To: Kathryn Espinoza, McKim & Creed
From: Brian Chambers, Assistant Director; 910.342.2782
CC: File;
Date: 5/14/2024
Re: Riverlights MX3 Townhomes TRC Rev 1

Project Name: Riverlights MX-3 Townhomes
Formal TRC Date: 5/16/2024
Reviewer: Eric Seidel, PE
Department: Engineering – Plan Review Section

Project Name: **RIVERLIGHTS MX3 TOWNHOUSES**

Project: Riverlights MX-3 Townhomes
TRC Meeting Date: 2/1/2024 ; 5/16/24
Reviewer: Anna Reh-Gingerich
Department: Stormwater

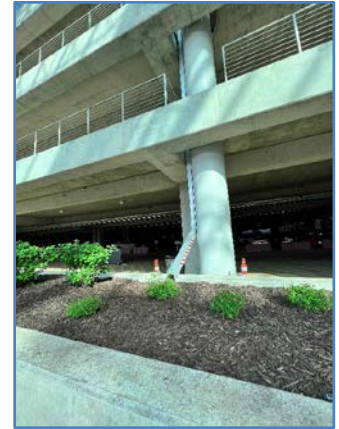
3. Consider green roofs, rainwater harvesting, or redirecting some downspouts from the buildings into stormwater planter boxes (as shown on the right) to help mitigate some of the roof runoff before draining to the drainage system:
